GLASTAR SERVICE BULLETIN 23

Subject: Door latch modification

Applicability: All GlaStar kits shipped prior to the publication of *Assembly Manual* Revision C.

Figure 2: Modifying the Center Latch Plate

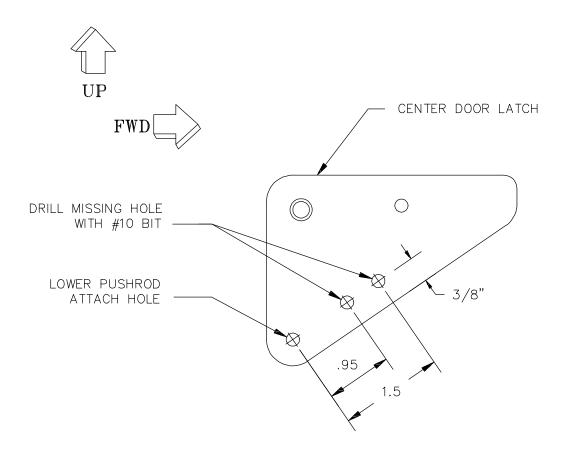
In order to facilitate installing the second over-center spring at a later date, if needed, we recommend drilling an additional hole in each of the center latch plates to bring the latches up to current specifications. Figure 2 shows the current latch, which has **two** #10-diameter holes along its lower edge spaced **.95**" and **1.5**" from the lower pushrod-attach hole. Early latches had one or the other of these holes, but not both. If your latch has a hole .95" from the pushrod-attach hole, drill a #10-diameter hole **1.5**" from the pushrod-attach hole; if your latch has the hole at 1.5", drill a #10-diameter hole **.95**" from the pushrod-attach hole. Repeat for both center latches.

Figure 3: Dual Over-Center Spring Installation

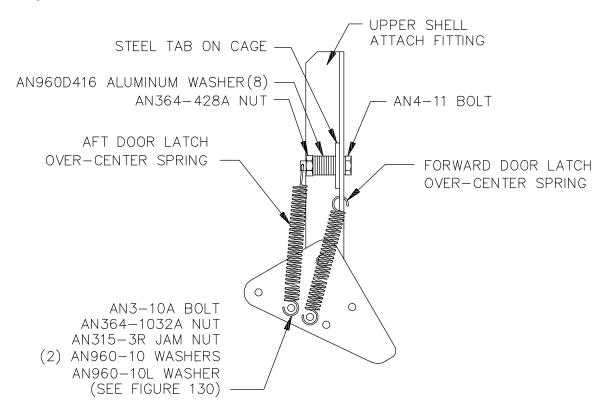
INSTALL A SECOND OVER-CENTER SPRING: The standard door latch configuration has been revised to include **two** over-center springs on each side. Installing the second spring is optional for builders of earlier kits who have already installed their latches; such builders may want to wait to decide whether to upgrade until they have flown their airplanes—it may turn out that just the new dog shape (if the original dogs weren't installed) eliminates any tendency for the doors to open in flight.

If you elect to use just the one spring originally specified, attach its lower end to the hole that is **1.5**" from the pushrod-attach hole in the center latch plate, using the hardware shown in Figure 130 in SECTION X of the *Assembly Manual*. Attach the upper end of the spring to the upper shell attach fitting, as described in the *Assembly Manual*. If you use two springs, install them as shown in Figure 3, below. Both springs in Figure 3 use the same attach hardware at their lower ends as that shown for the single spring in Figure 130.

Note The second over-center spring and its mounting hardware were not included in early kits, but they will be supplied in a Parts List Addendum. You will receive two each of the forward door latch over-center springs (P/N 077-00002-02), two each AN4-11 bolts, two each AN3-10A bolts and two each AN315-3R jam nuts. Various washers and elastic stop nuts are also needed in the installation, but there should be enough extra of these in the original kit to satisfy your needs. Use the original spring supplied with your kit as the aft spring.

Figure 4: Latch Arm Extensions

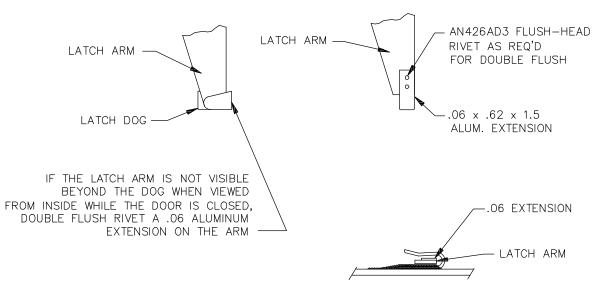
EXTEND THE DOOR LATCH ARMS: It's possible that some of the door latch arms (the forward upper latch arms, in particular) may inadequately engage the door dogs. If the ends of the forward upper door latch arms are not visible beyond the door latch dogs when the latches are closed, double flush rivet **1/16"-thick aluminum extensions** onto the arms, as shown in Figure 4. The extensions will help retain the latch arms more securely in the dogs. Alternatively, you can purchase the redesigned forward upper door latches (P/N 101-16001-03 and -04), which are 1/2" longer. If any of the **builder-fabricated** door latches are too short, make new, longer ones.

To double flush-rivet the extensions on the forward upper latches, simply countersink **both** parts and then buck the rivets normally, allowing the shop head to deform into the countersink on the back side. Any part of the shop head that protrudes beyond the surface after bucking can be filed off flush. The shop head won't completely fill the countersink, but it will spread out enough to securely retain the extension.
